Access Compliance Report Public Rights-of-Way (Curb Ramps)

Intersection ID: 10037015 Main Street: S TRYON ST Cross Street: N/A Location: Initial Pass/Fail: Fail **Overall Compliance: No** ADA ID: C6F2CC4F6AE8 Ramp Type: BlendTrans1 Severity Score: 33.75

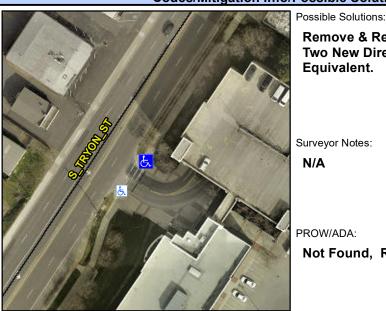
Not Found, R304.5.1, R304.5.3

No No Ramp Width (in) 38.0 BlendTrans XSlope (%) N/A N/A Flare Type LT N/A Flare Type RT N/A Flare Slope LT (%) N/A N/A Flare Slope RT (%) N/A Flare Traversable LT? N/A N/A Flare Traversable RT? N/A N/A N/A **DWS Provided?** Landing Length (in) N/A Landing Width (in) N/A N/A **DWS Contrast?** N/A N/A N/A Landing Slope (%) DWS Length (in) N/A Landing X Slope (%) N/A N/A DWS Full Width? N/A Landing Curb? (Y/N) N/A N/A DWS Offset (in) N/A N/A Shared Landing? N/A **Gutter Ponding?** N/A N/A Gutter Slope (%) N/A Gutter Lip Ht (in) N/A N/A Gutter X Slope (%) N/A Painted X Walk1? No N/A Painted X Walk2? X Walk 1 Direction To W X Walk 2 Direction N/A X Walk 1 Width (in) X Walk 2 Width (in) X Walk 1 Slope (%) 10.3 X Walk 2 Slope (%) X Walk 1 X Slope (%) 2.4 X Walk 2 X Slope (%) N/A N/A Ramp inside XWalk2? N/A Ramp inside XWalk1? Road Slope (%) 10.0 Clear Space? Road X Slope (%) N/A Clear Space to XWalk (in) 4.3 N/A N/A N/A Any Obstructions? Storm Grate/Utility Hazard?

Street 1 Name Stop Condition-Street 1 Street 2 Name Stop Condition-Street 2 Remove & Replace Curb Ramp With Two New Directional Ramps or Equivalent.
